## **ZONING CHANGE REVIEW SHEET**

**CASE:** C814-2017-0001 – 425 W. Riverside PUD

**ADDRESS:** 425 W. Riverside Drive

**ZONING FROM:** CS-1-V-NP      **TO:** PUD-NP

**EXHIBIT E**

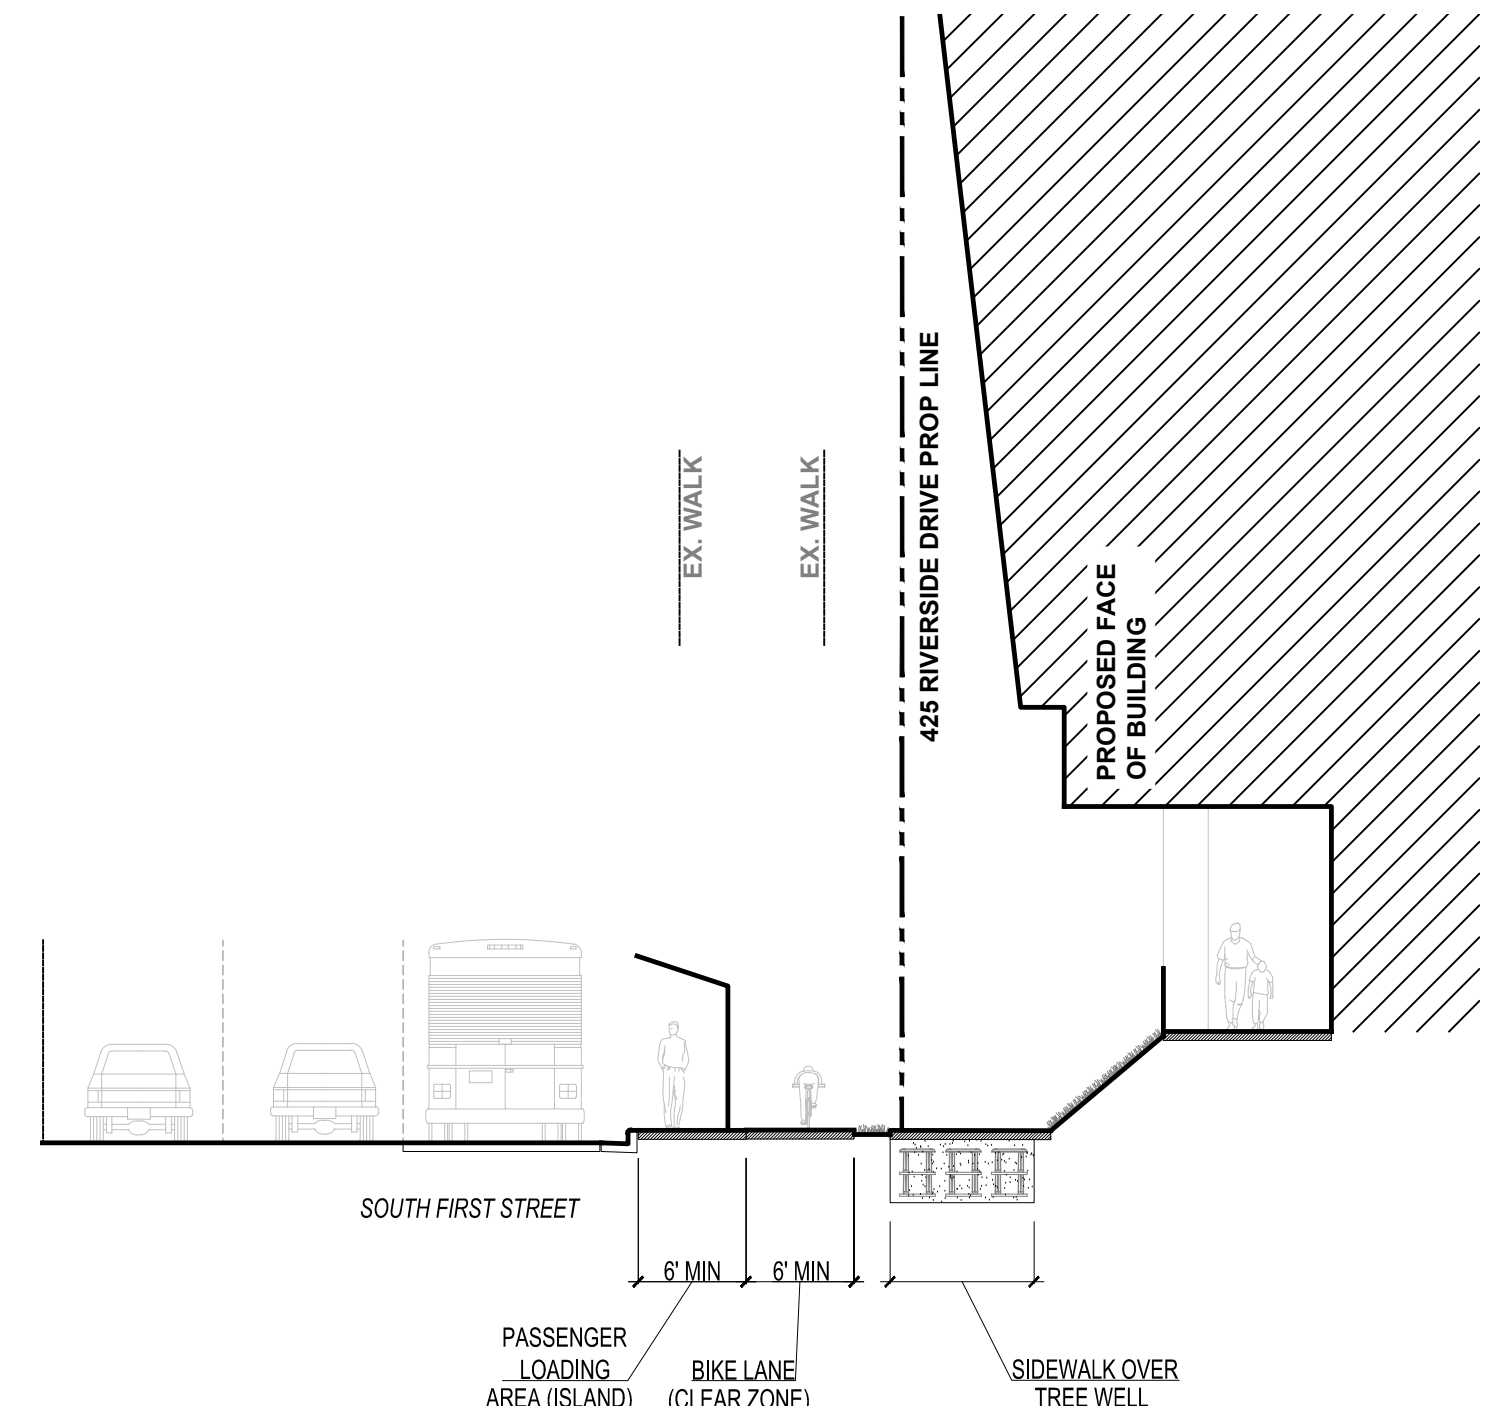
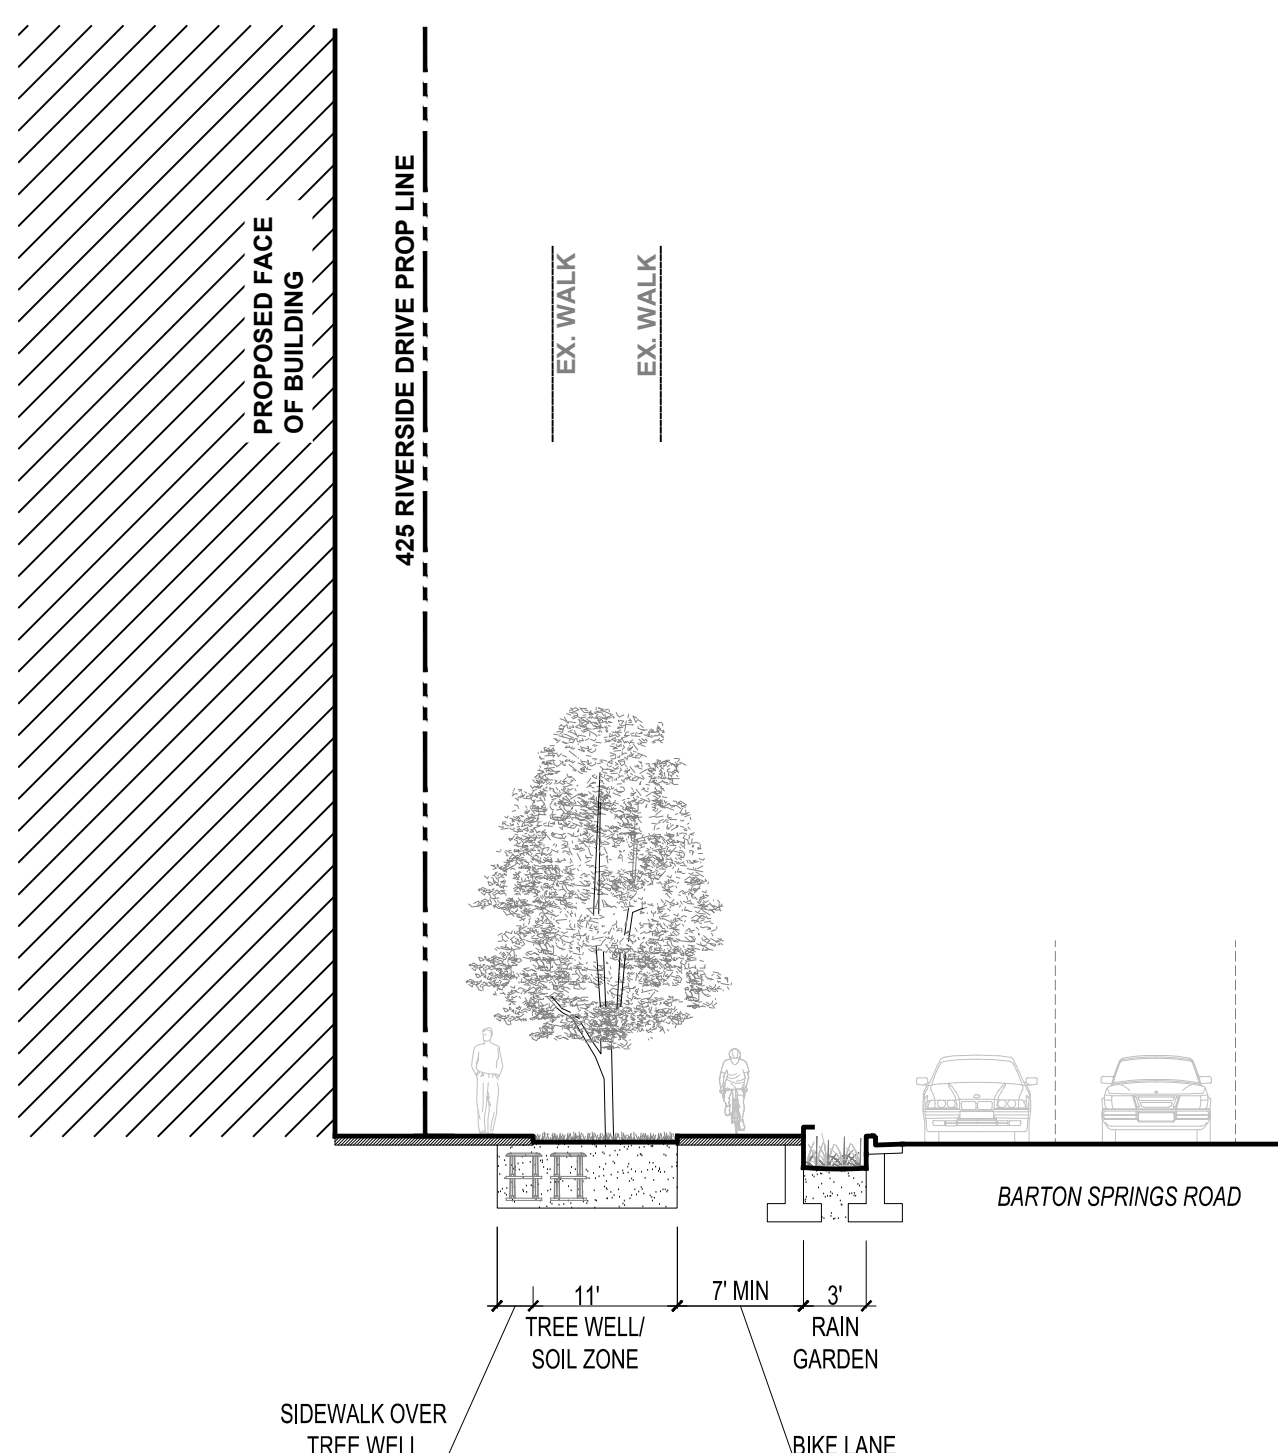
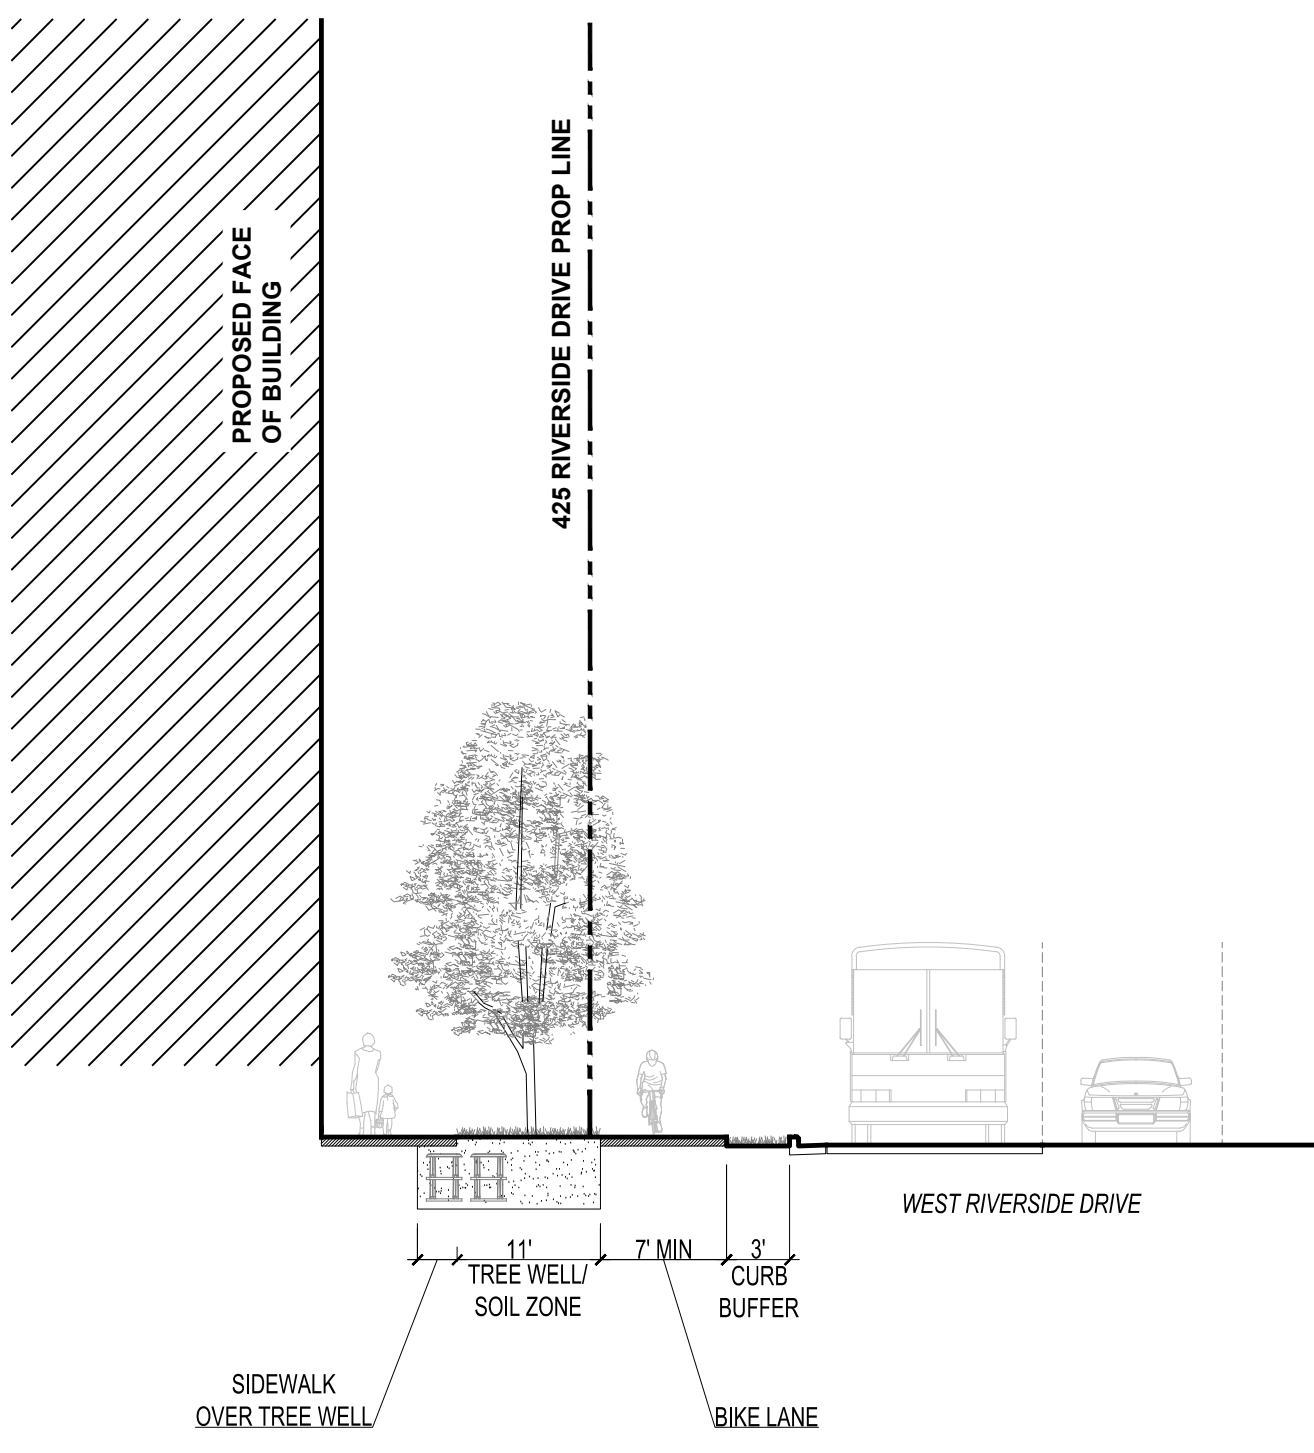
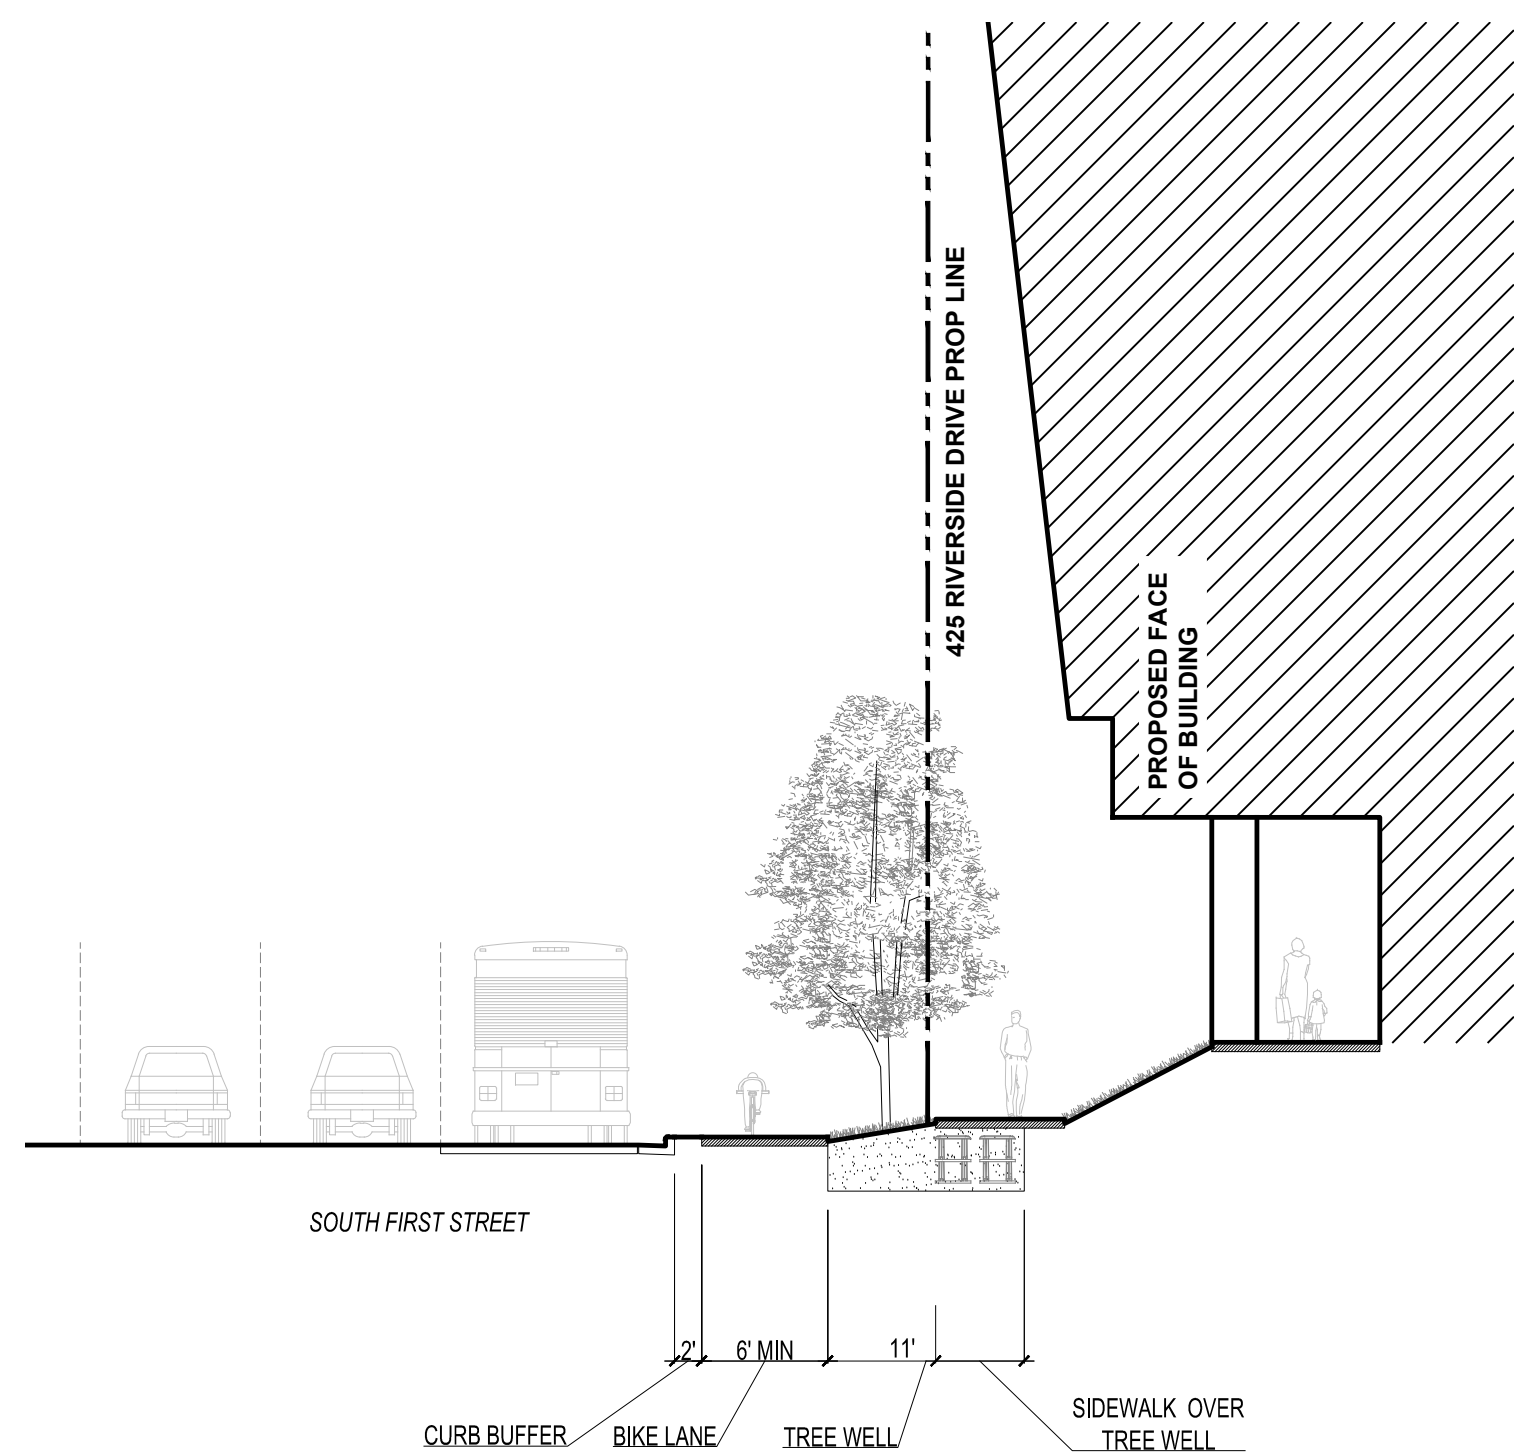
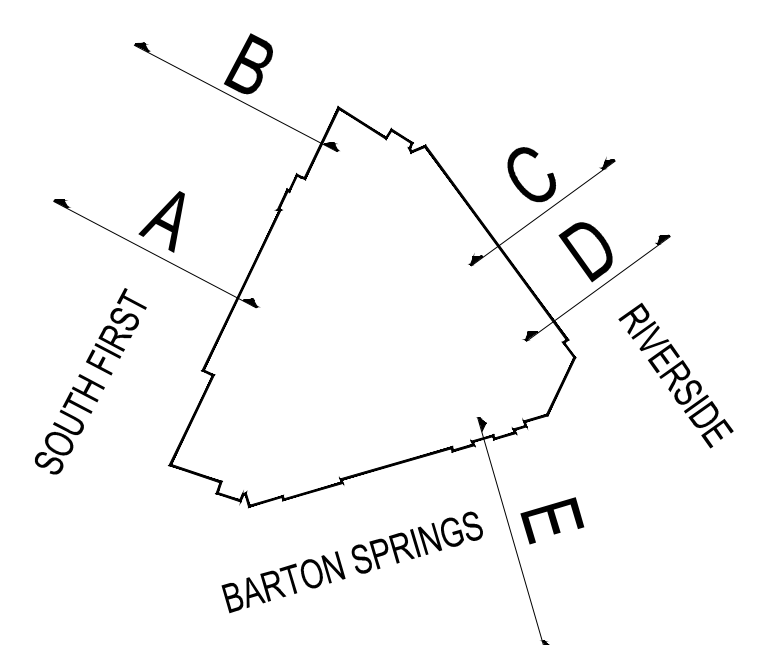
- #3 Bicycle Lane Width - the bicycle lane widths do not conform to the original drawing I sent in May. In the attached Exhibit C and E I have marked up width changes. In short the following are the dimensional requirements for the bicycle lane in a few scenarios:  
If pavement on either side of bicycle lane is not rideable than 7' is the minimum bikeway dimension.

If there is a dropoff into a rain garden there needs to be a hand rail that is recessed from the bike lane by 6" as to not encroach in the bicycle lane space (handrails should be added to relevant cross sections in exhibit E. If there is rideable pavement on both sides of the bike lane the minimum acceptable dimension is 6'
